**DEVELOPMENT REVIEW COMMITTEE (DRC)
 Site Plan Application**

Case Number	RZ 17003
Date of complete submittal	1-20-17

Development / Project Name	2980 Restaurant & Retail
Development / Project Address	<u>Existing:</u> 2980 2990, 2960 N Federal Highway <u>New:</u> 2980, 2990 N Federal Highway
Legal Description	Lots 4 and 5, Block 66, and a portion of Lot 2, Block 61 CORAL RIDGE GALT ADDITION NO. 1, Plat Book 31, Page 37 (see full legal description attached)
Tax ID Folio Numbers (For all parcels in development)	494225044560, 494225044570, 494225045130, 494225045140
Request / Description of Project	Site Plan Level IV, Rezoning from RMM-25 to Exclusive Use X-P with Commercial Flex Allocation, Alley Vacation
Total Estimated Cost of Project	\$ 2,750,000 <i>(Including land costs)</i>

PROJECT: **2980 RETAIL / RESTAURANT BUILDING**
2980-2990 NORTH FEDERAL HWY
FORT LAUDERDALE, FL 33306

PROPOSED SITE PLAN
SCALE: 1/16" = 1'-0"

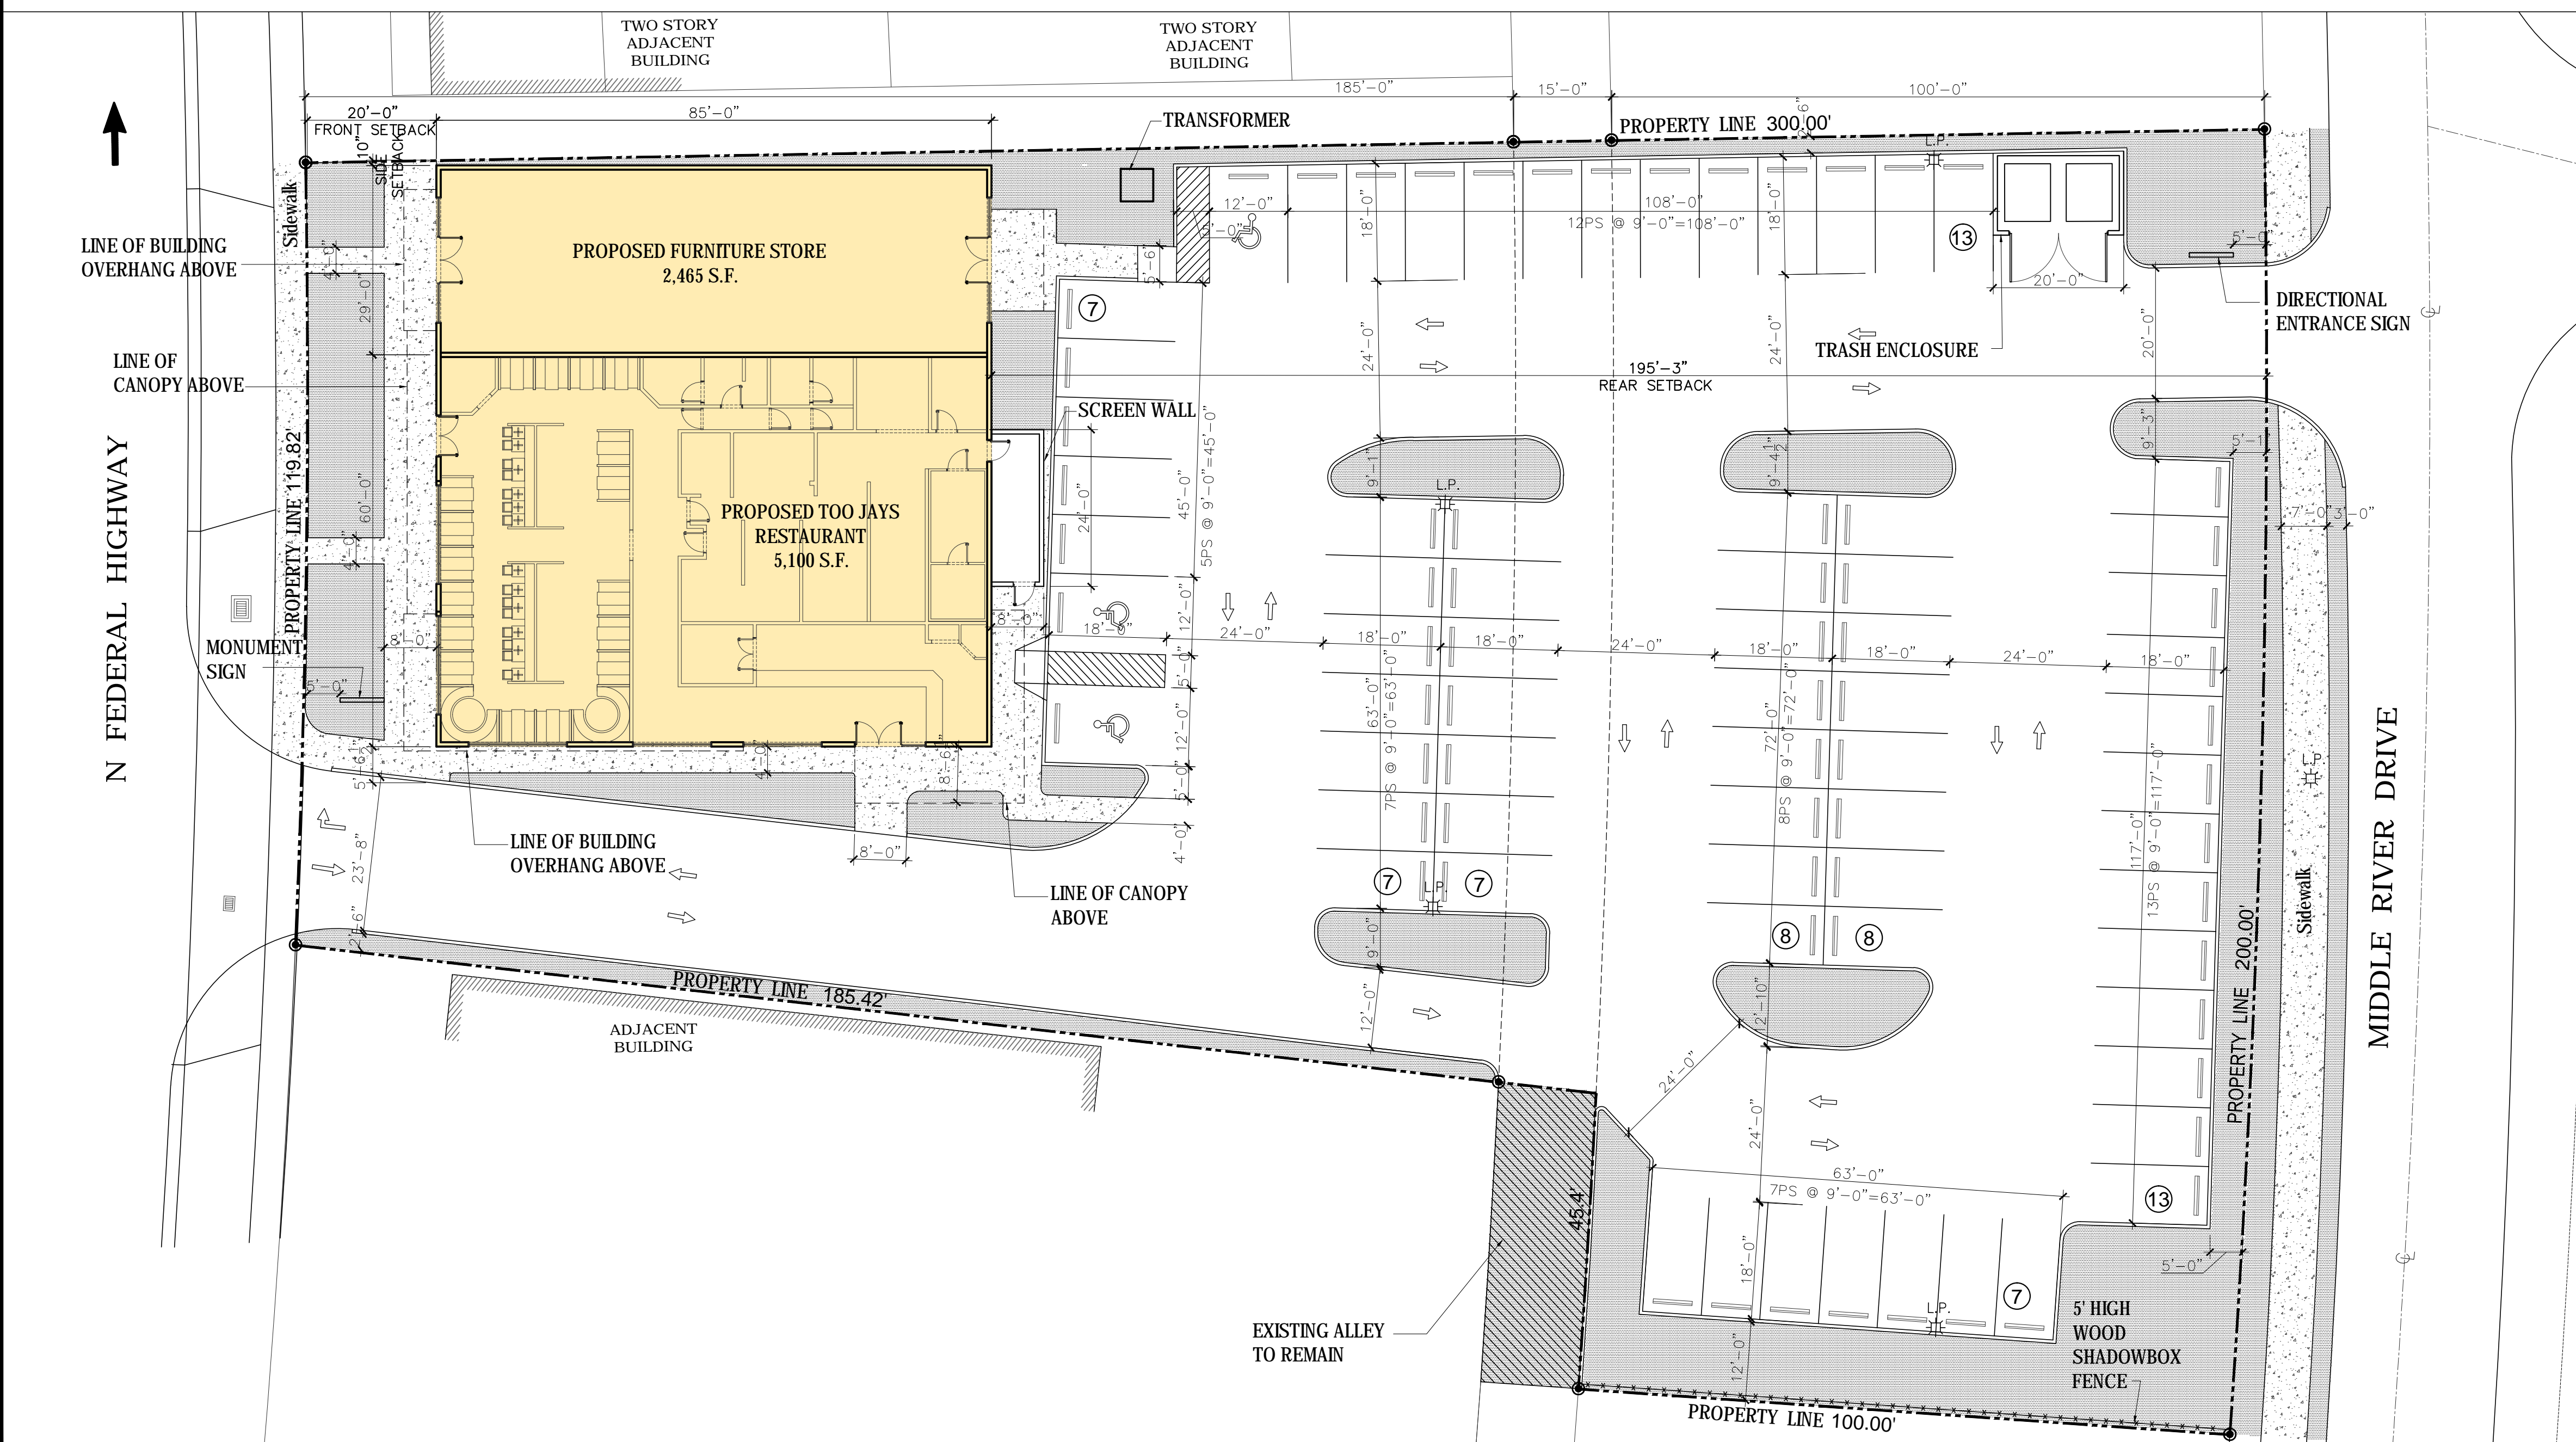
1. Please show all sidewalk dimensions on the site plan, including all pinch points on the site.
2. Please provide a 7 foot sidewalk along US1.
3. Please connect the 5 foot sidewalk along Middle River Dr to the existing sidewalk north of the site.

SHEET NUMBER
A-3.0

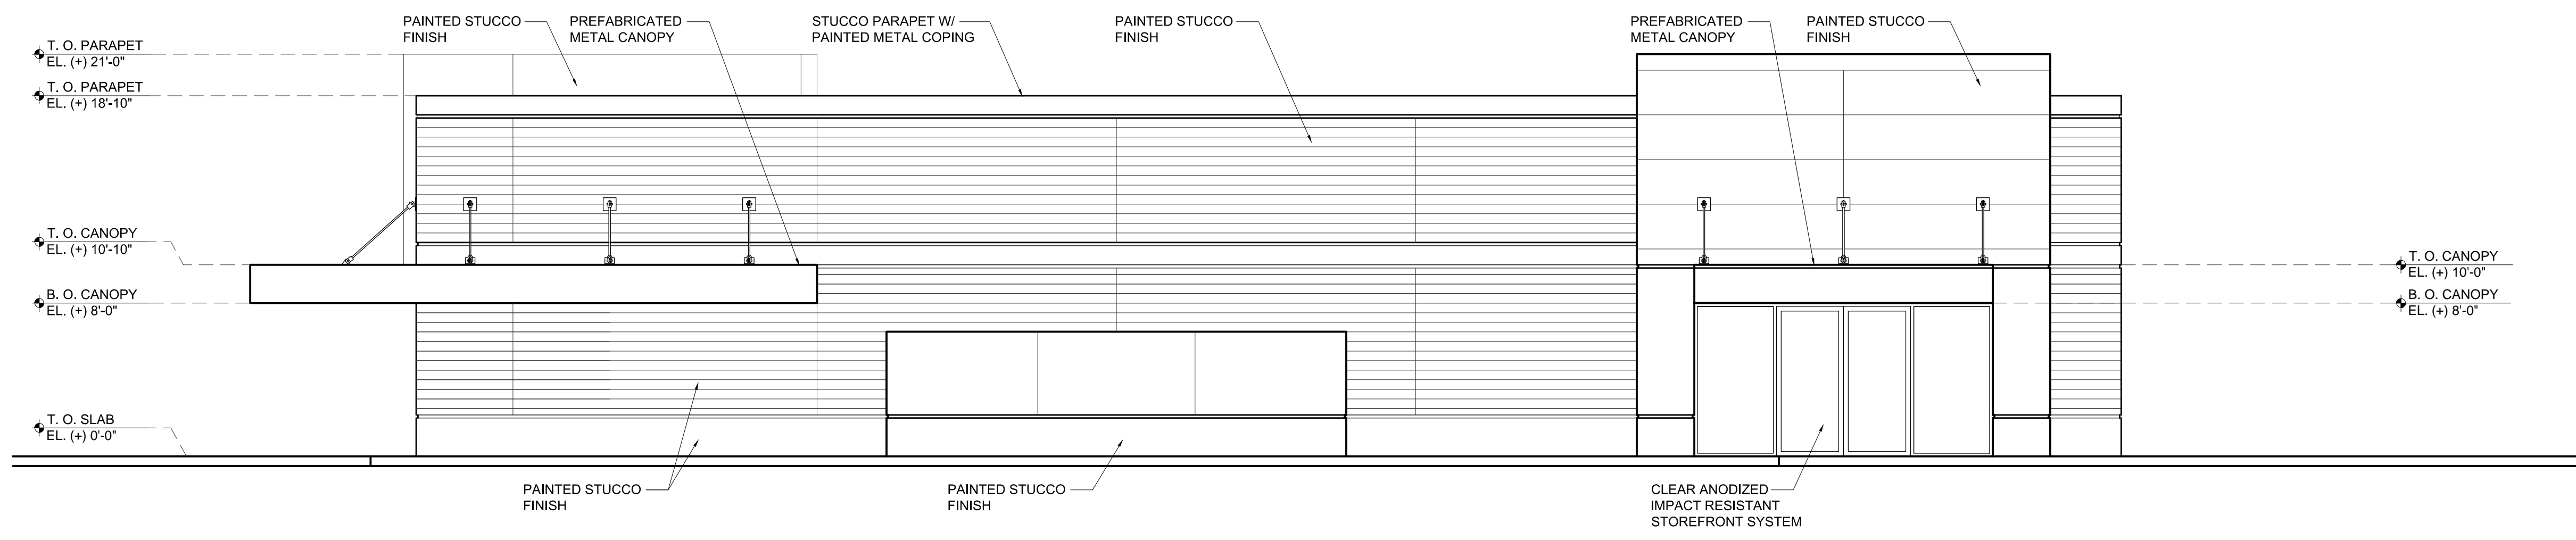
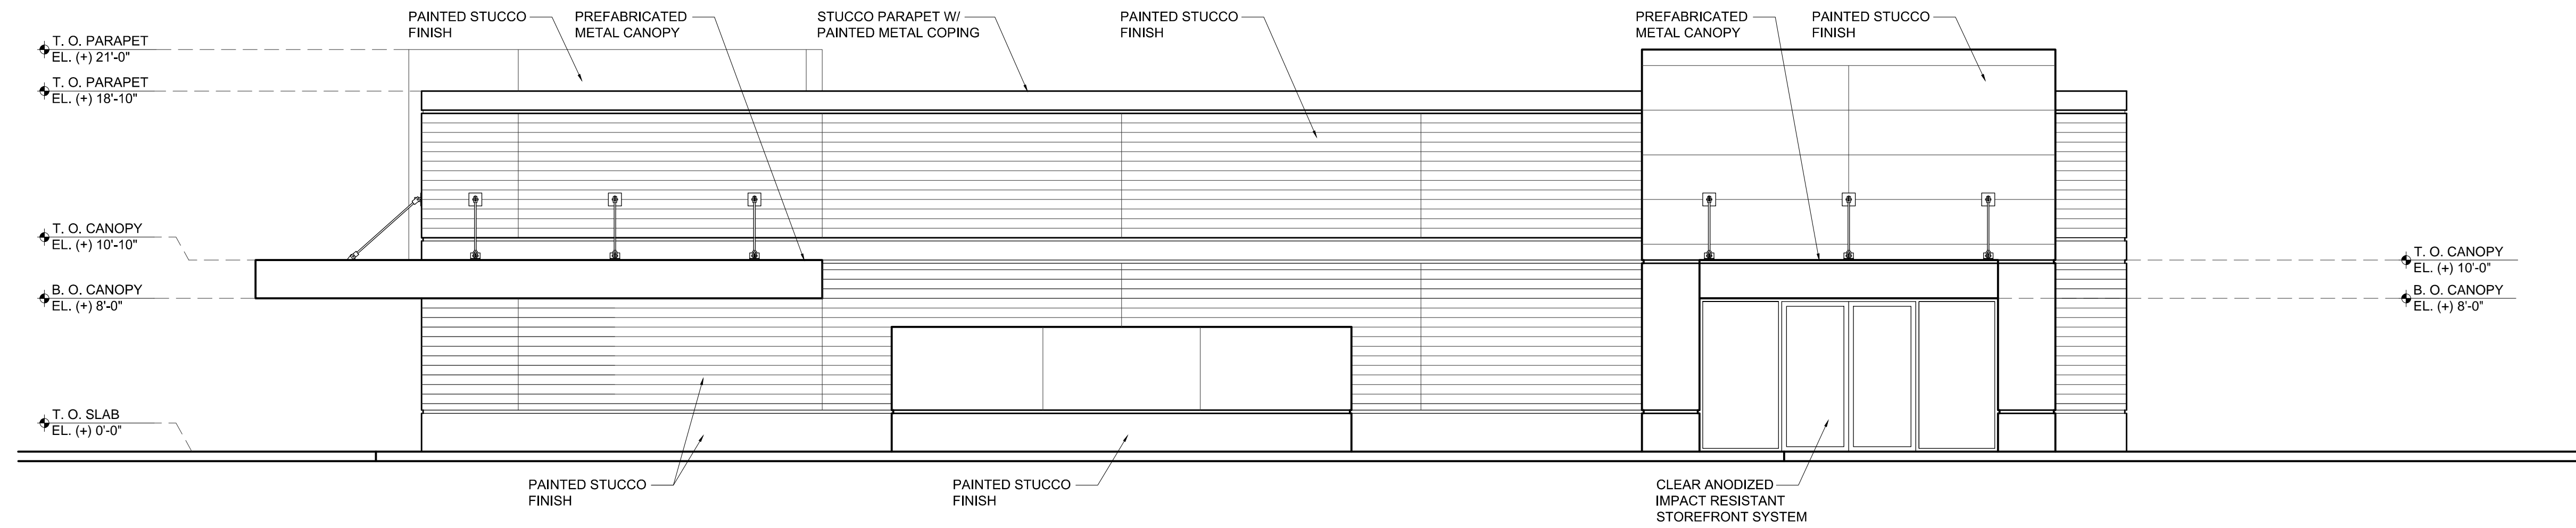
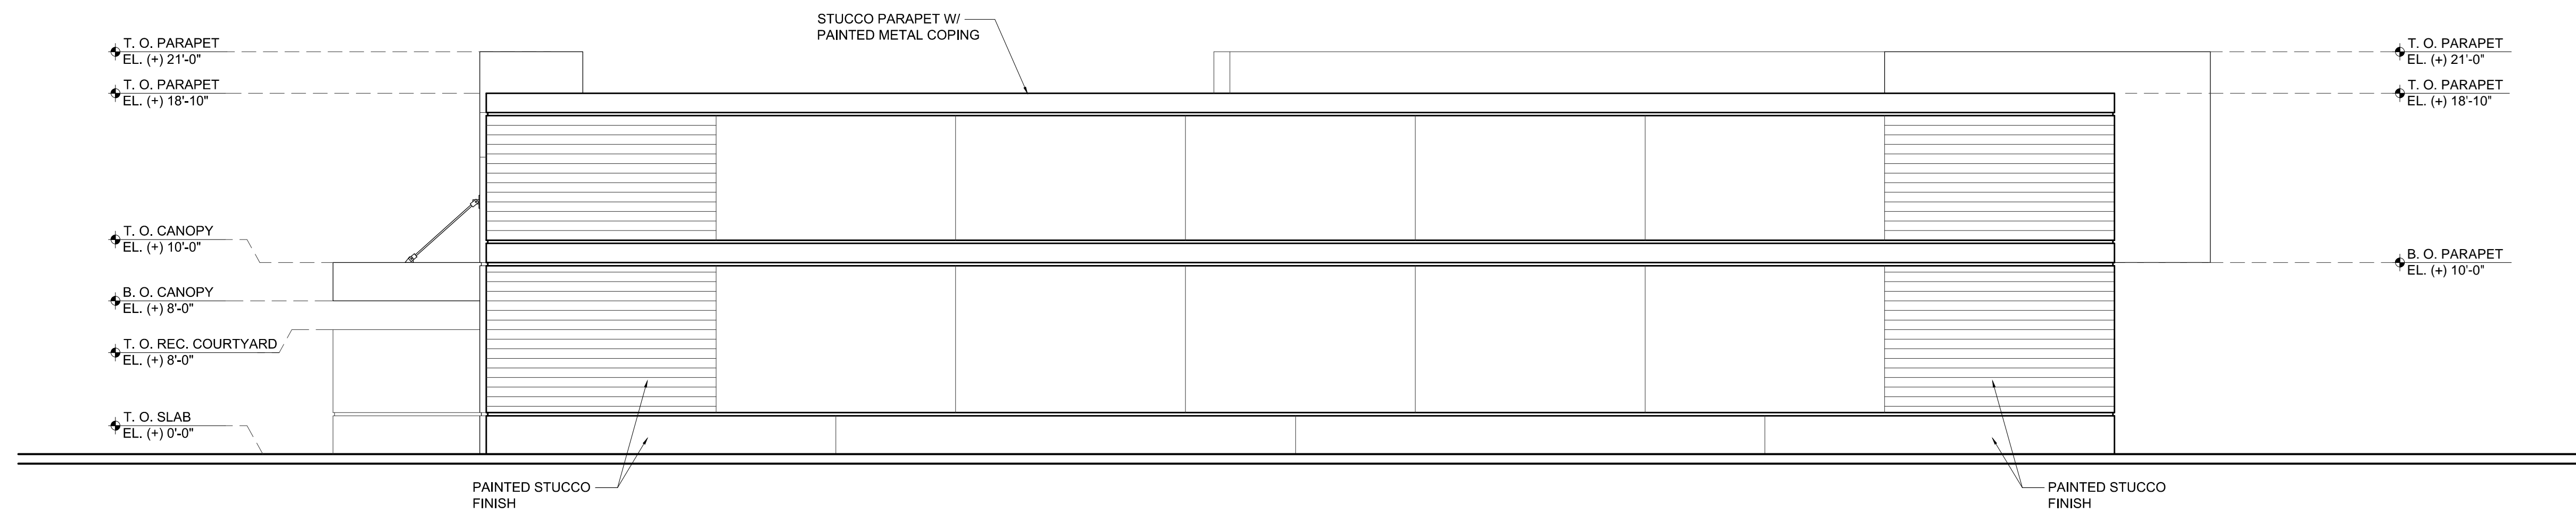
16. Provide typical roadway cross-sections and dimensions for proposed development side adjacent to US 1 / N Federal Highway and Middle River Drive.
17. Sheets A-3.0 thru A-4.1 (4 Sheets total): Show and label existing Right-of-Way boundaries, proposed Right-of-Way and/or Easement boundaries, and horizontal building clearances on all building
